SERVICE BULLETIN

CABIN ENTRY/EGRESS STEP MODIFICATION

- A. Aircraft Affected: All McDonnell Douglas Helicopter Systems (MDHS) MD900 Series Helicopters, serial numbers 00002 thru 00051.
- B. Assembly/Components Affected by this Notice: Cabin Step Installations, P/N 900F7301000-101 and 900F7301010-101.

Figure 1. Cabin Step Modification Installation.

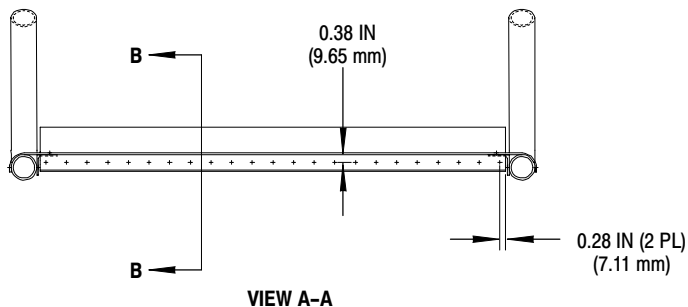
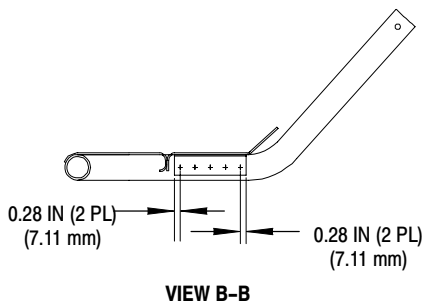
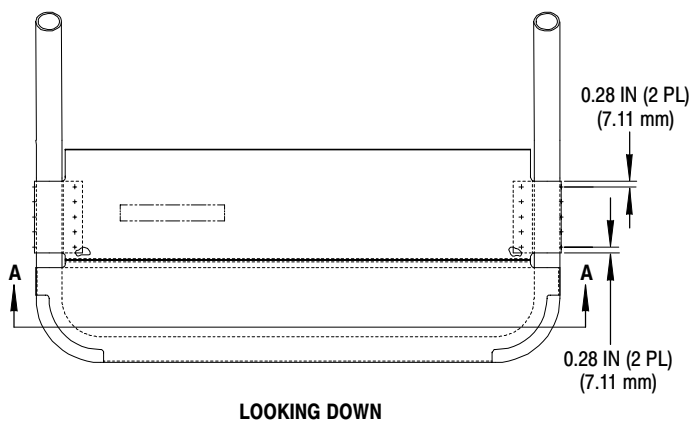
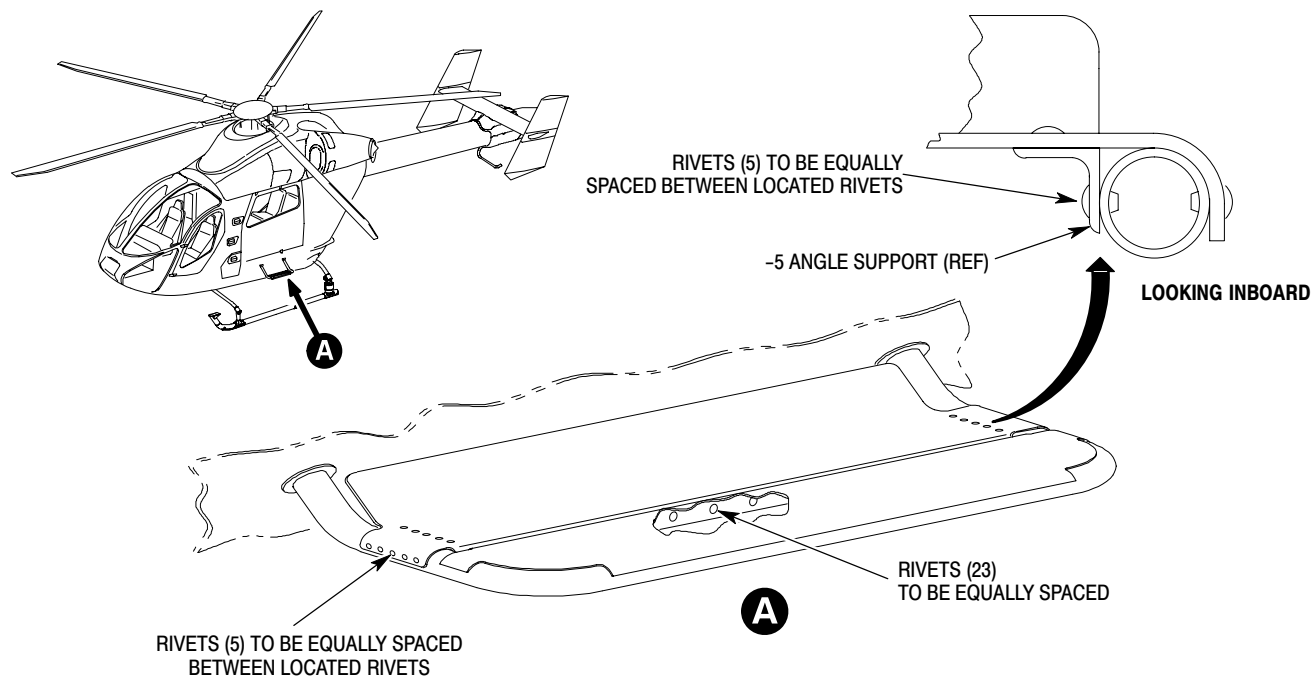
- C. Reason: Based on field reports, MDHS has improved the design of the cabin step assembly. This redesign will provide a step that is greater in size, thus allowing for increased footing during cabin entry/egress.

A. Install cabin step modification sub assembly as shown in Figure 1.
